October 2, 2014

David K. White, PE
Corporate Regulatory Affairs
AREVA Inc.
3315 Old Forest Road
P.O. Box 10935
Lynchburg, VA 24506-0935

SUBJECT: REQUEST FOR CLARIFICATION RELATED TO THE AREVA FILTERED
CONTAINMENT VENTING SYSTEM TO SUPPORT THE CONTAINMENT
PROTECTION AND RELEASE REDUCTION FOR BOILING WATER REACTOR
WITH MARK I AND MARK II CONTAINMENTS RULEMAKING

Mass Fraction Distribution Chart

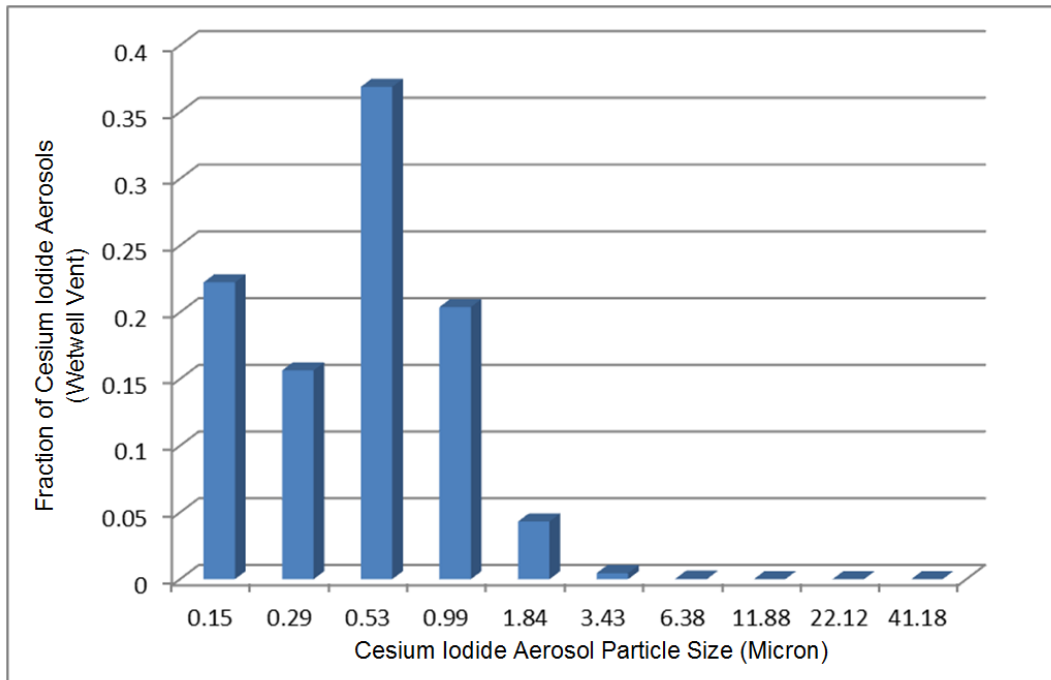
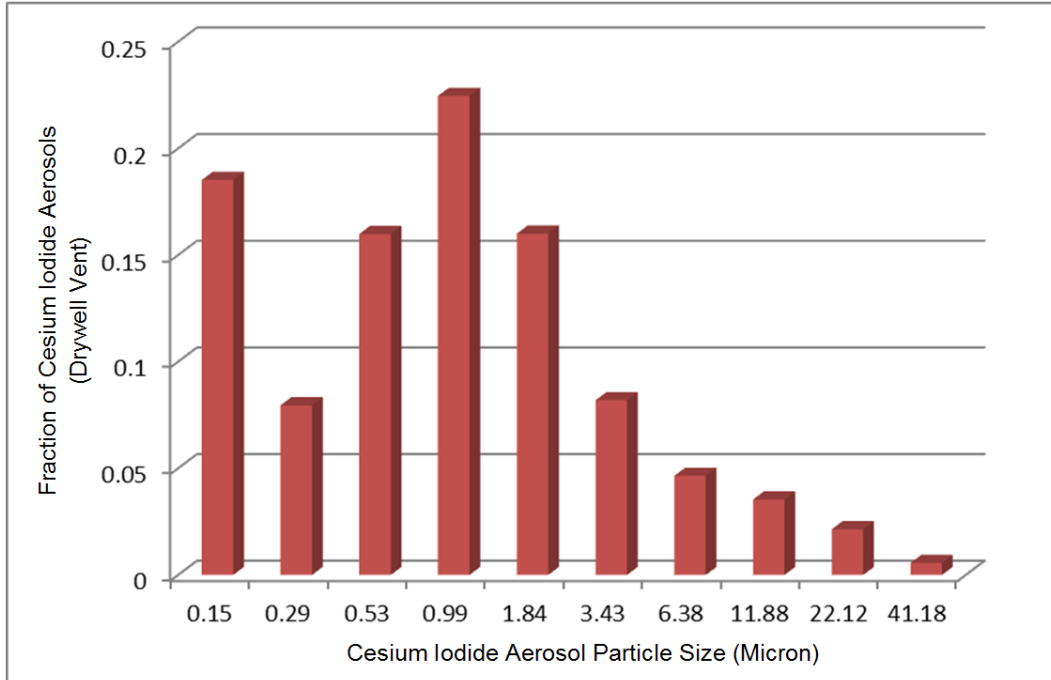
The NRC staff's analyses of certain severe core damage accidents caused by an extended loss of AC power have shown that the particle size spectrum reaching the filter is dominated by particles less than one micron Aerodynamic Mass Median Diameter. Example mass fraction distributions of Cesium Iodide (CsI) reaching the wetwell and drywell vents are shown in the enclosure. Thus, these particle sizes determine the actual effectiveness of the engineered filter in the application we are assessing. The NRC staff is unable to determine the decontamination factors (DF) for these particle sizes from the integrated DF values and design descriptions provided in Areva's presentation to the NRC staff. It would benefit the NRC staff if Areva provides the DF by the particle size in the range shown in the enclosure, broken down if possible by the contribution from each stage in the filter (e.g., venturi, pool, and demister).

The NRC staff is also requesting the detailed basis for the DF values you provide (i.e., experimental data and modeling). This information is necessary to respond to the Commission's direction to provide the validation and testing needed should an engineered filter be included in the requirements of the rulemaking.
